PLANNING REPORT

Architectural Review Board

Laird Residence 25-025MPR

Location	PID 273-013558 - East side of S. Riverview Street, approximately 200 feet north of Short Street.
Proposal	Construction of new residence on .27-acre site.
Request	Review and approval for Minor Project Review (MPR) under the provisions of Zoning Code Section 153.176.
Zoning	HD-HR, Historic Residential District
Planning Recommendations	<u>Approval of Waivers</u> <u>Approval of MPR with Conditions</u>
Next Steps	Upon approval of the Minor Project Review and Waivers, the applicant may apply for building permits through Building Standards.
Applicant	Taylor Sommer, His and Hers Architects
Case Manager	Sarah Tresouthick Holt, AICP, ASLA, Senior Planner (614) 410-4662 sholt@dublin.oh.us

East Elevation

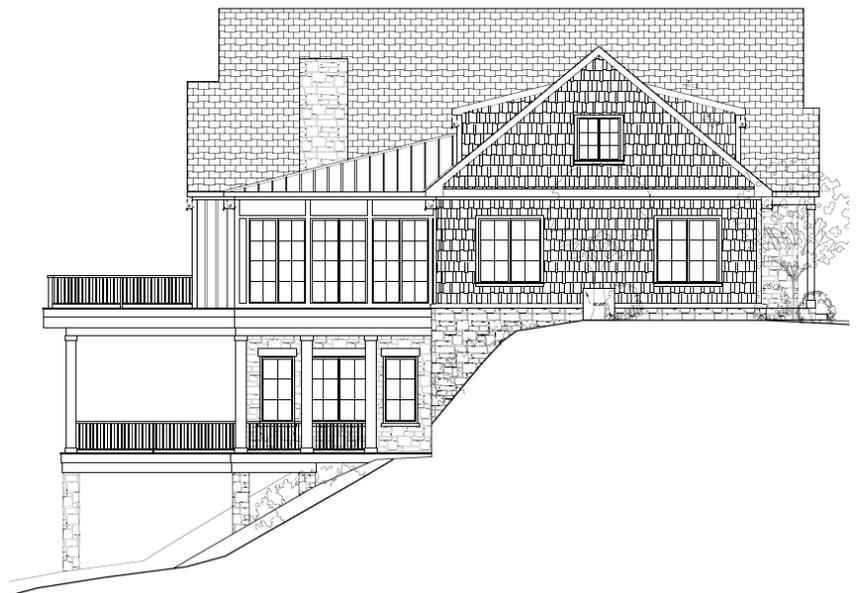
East Elevation/Scioto River

The rear elevation is also as presented at Informal. The total height here is noted as 40 feet to the mid-point of the gable; this requires a Waiver, which is supported based on site topography.

The cross gable is visible on the left side and the bay below contains the majority of the rear decking. A sub-gable is brought slightly forward with a greater number of windows, plus deck access. The right side contains a sunroom. Its roof slope requires a Waiver, for which the Board indicated support at Informal. The right side has a shed roof dormer, also needing a roof slope Waiver.

Window arrangements meet Guidelines recommendations for placement and proportion. Window frames, sills, and lintels are provided according to Code.

South Elevation

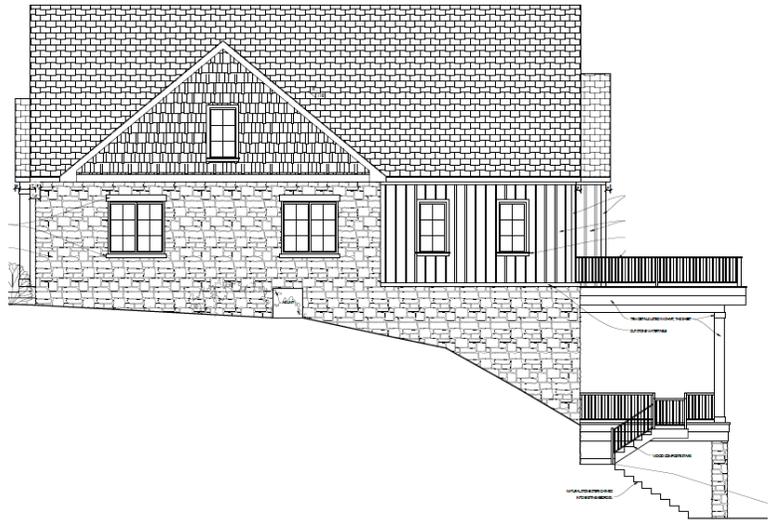
South Elevation

The same cross gable effect is evident on this side elevation.

This elevation also shows regularly-placed windows, the slight protrusions for the front door and center sub-gable, and the stacked decks. All roof pitches on this elevation meet Code requirements.
